**URGENT MEDICAL DEVICE CORRECTION**

**Level 1® H-2 Pressure Chamber Door and Latch Replacement Kits**

20 May 2024

Figure 1: Incorrectly installed bag hooks, misoriented 180°

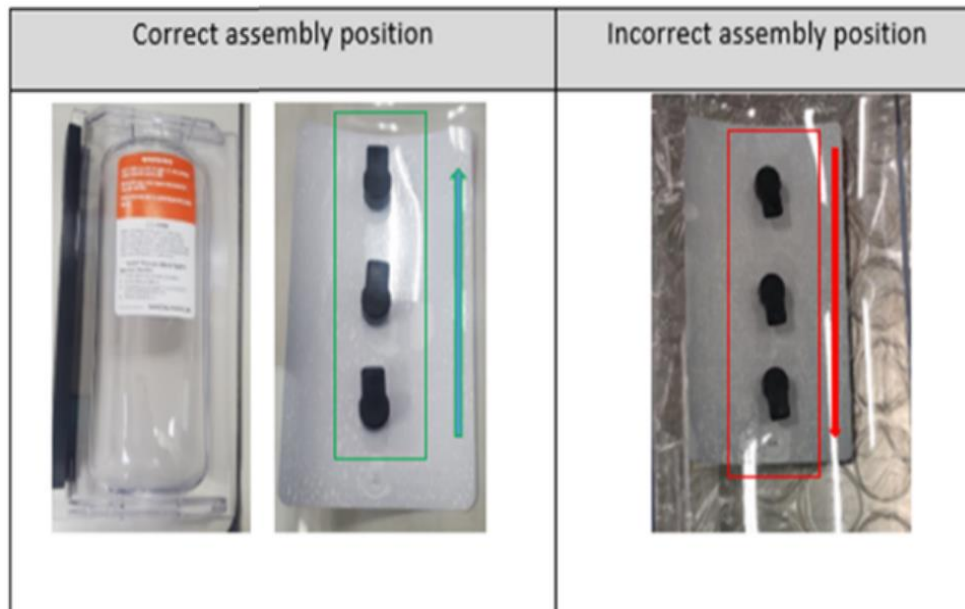
During an internal inspection, it was identified that bag hooks in certain Level 1 H-2 Pressure Chamber Door and Latch Replacement Kits may have been assembled in an incorrect position. Refer to Figure 1 for an image of incorrectly installed bag hooks.

Improperly assembled bag hooks will not allow for proper bag placement within the pressure chamber and may lead to delay of therapy or the inability to complete a full infusion of infusate.

1. Identify all affected Level 1 H2N or 7802722 kits (including those installed into H-2 Pressure Chambers) in your possession:
  - a. Compare the orientation of the bag hooks inside the doors with the correct assembly shown in the above image.

- c. If the bag hooks are assembled incorrectly, then your product is affected, and it will need to be removed from service and replaced. **Do not attempt to use or repair the affected product.** Complete the attached Response Form identifying the number of affected products in your possession.
